**OHIO TURNPIKE AND  
INFRASTRUCTURE COMMISSION**

**ADDENDUM NO. 1**

**PROJECT NO. 59-19-01  
REPAIRS AND RESURFACING  
EASTBOUND AND WESTBOUND ROADWAYS  
MILEPOST 7.19 TO MILEPOST 14.80  
AND PARTIAL EASTBOUND SHOULDER RECONSTRUCTION  
MILEPOST 2.87 TO MILEPOST 7.19  
WILLIAMS COUNTY**

**MODIFICATIONS TO THE CONTRACT DOCUMENTS**

**RESURFACING PLAN**  
**STA. 389+56.27 TO STA.680+00**

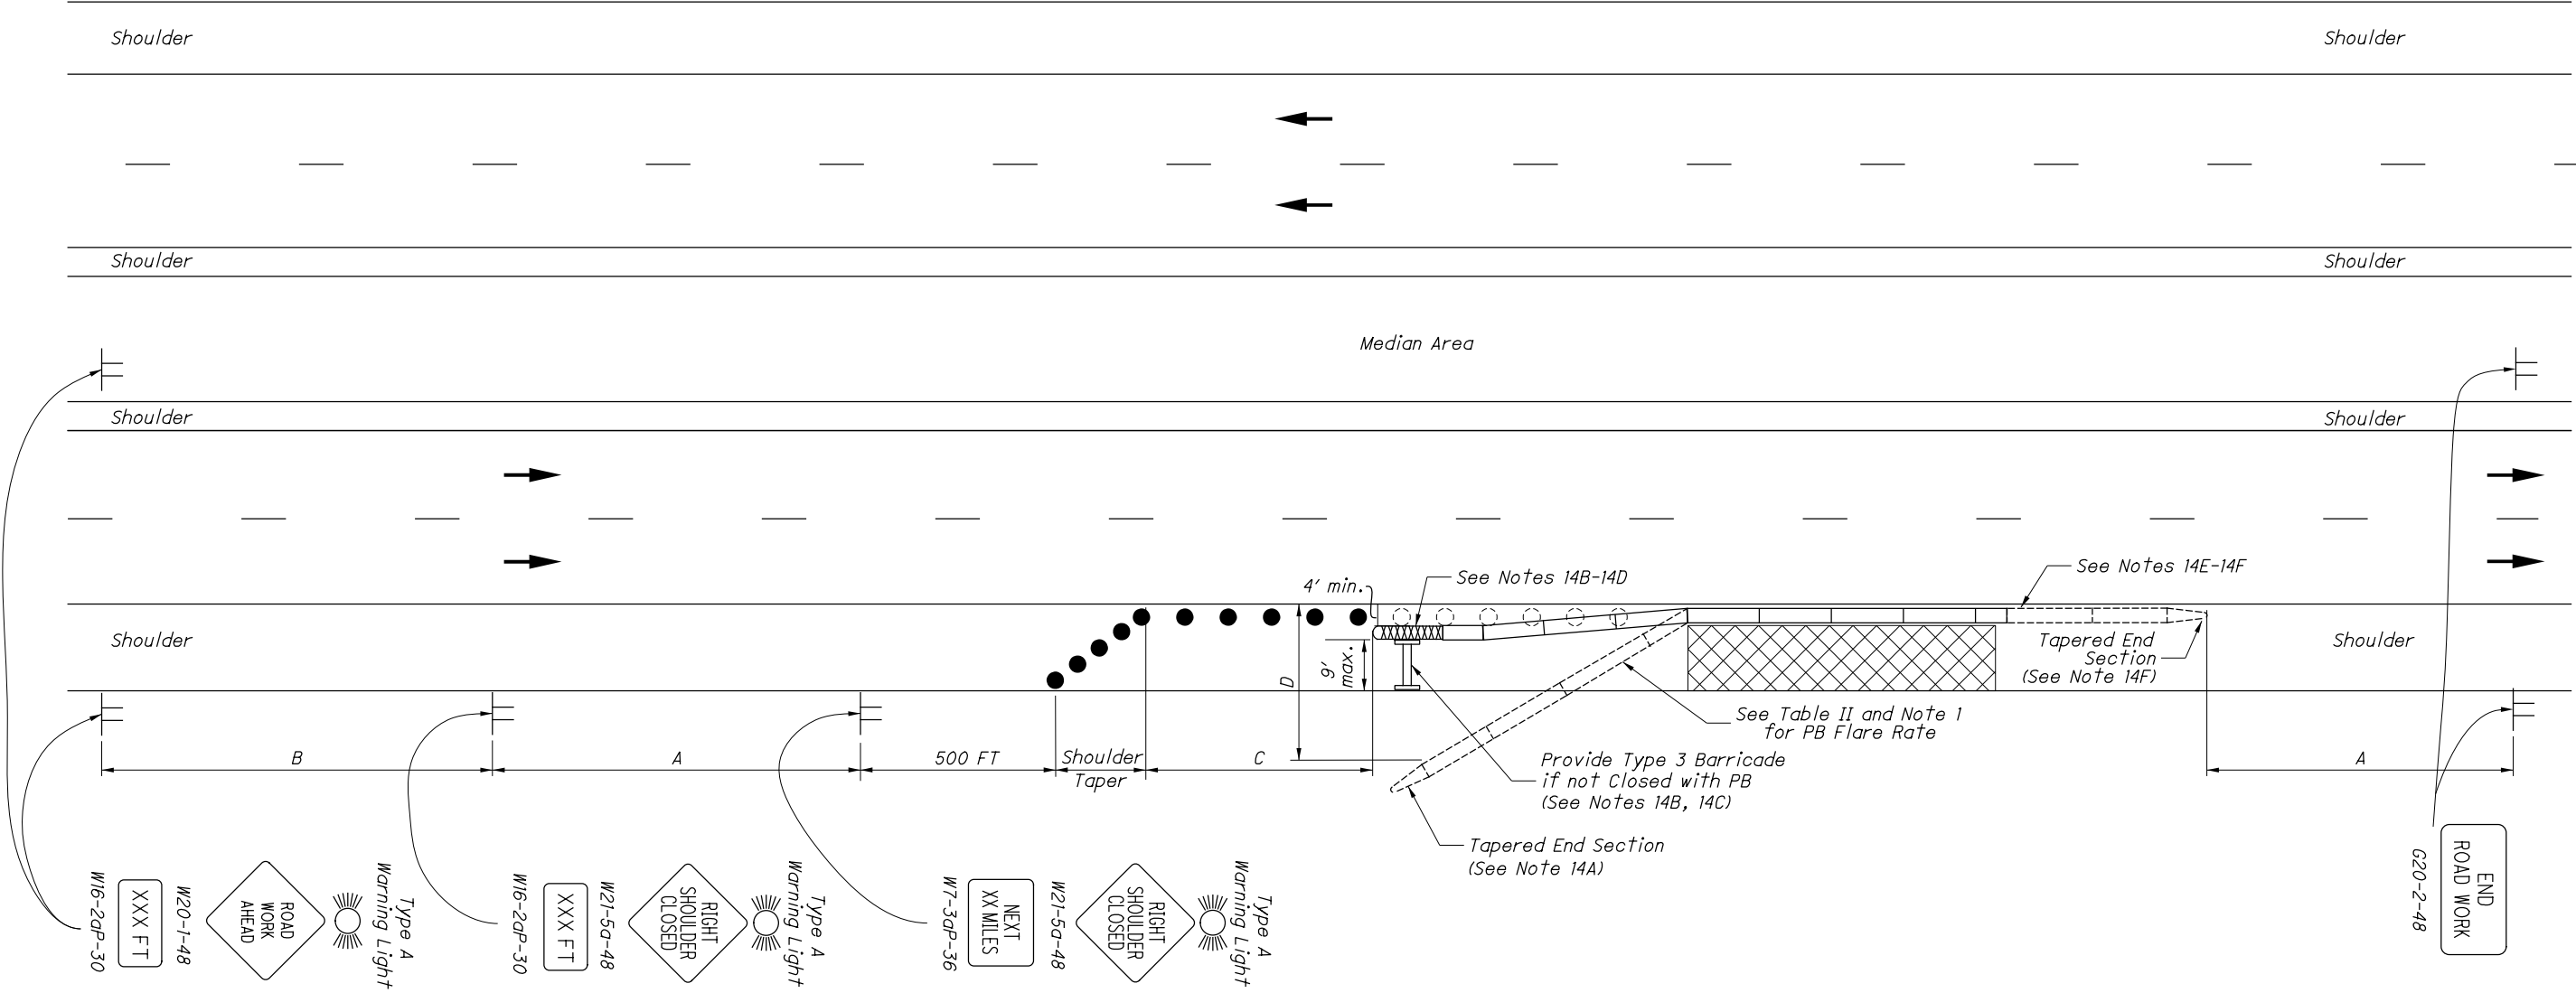
**Q#9 On plan sheet #'s 2 and 3, a note #3 is referenced at many of the existing cross-overs, is this reference supposed to be to note #2?**

**Q#20 Please review Plan Sheets 2 and 3, as it appears that the reference to Note 3 for the existing cross overs should be to Note 2 on Plan Sheet 2, please clarify.**

*A#9 Plan sheets 2 of 14 and 3 of 14 have been revised to reference plan note #2. Revised Plan Sheet 2 of 14 and 3 of 14 have been included with this Addendum No. 1.*

- 2 - REMOVE 2" MINIMUM WEARING SURFACE COURSE, PER ITEM 254, OF THE EXISTING CROSSOVER, TACK COAT THE MILLED SURFACE WITH ITEM 407 - NON-TRACKING TACK COAT, AND RESURFACE WITH 2" MINIMUM ITEM SP 404 - ASPHALT CONCRETE SURFACE COURSE, USING CRUSHED STONE, PG64-22. SEE OTIC STD. DWG. XO-V-1 FOR ADDITIONAL DETAILS. CONTRACTOR SHALL REPAVE THE CROSSOVER IN SUCH A MANNER SO AS TO ENSURE THE CROSSOVER PROPERLY DRAINS. ALL LABOR EQUIPMENT MATERIALS AND INCIDENTALS SHALL BE INCLUDED IN THE PERTINENT BID ITEMS.
